Proposal for an additional correction to ECE/TRANS/GRE/2009/66

Regulation No.6 (Direction indicators) Annex 1, amend to read:

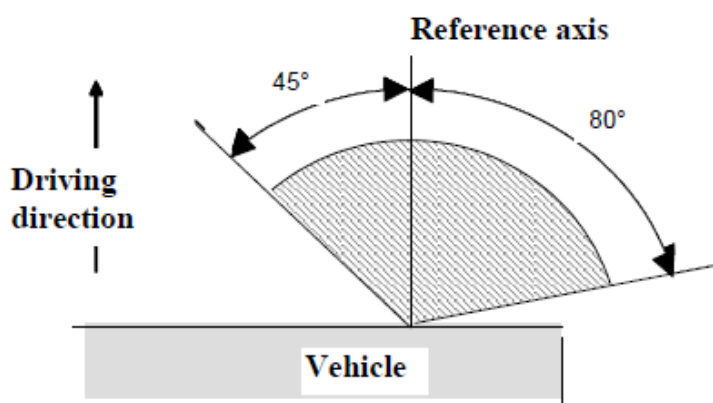
On and above the H plane
for all lamps.

Under the H plane for
lamps intended for:

- (a) M_2 , M_3 , ~~N_2~~ or N_3
category of vehicles or
- (b) M_1 or N_1 category of
vehicles and being installed
at a mounting height of
equal to or more than 750
mm above the ground.

These texts were approved at one-hundred-forty-seventh session of WP.29 as ECE/TRANS/WP.29/2009/13. But N_3 category seems to be missing.

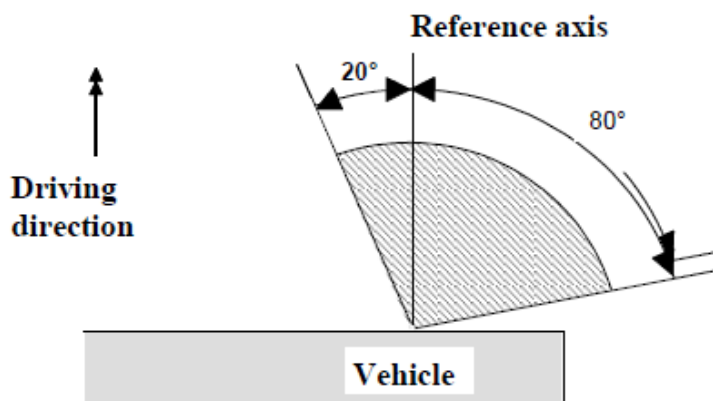
Under the H plane for
lamps intended for M_1 or
 N_1 category of vehicles,
and being installed at a
mounting height less than
750 mm above the ground.
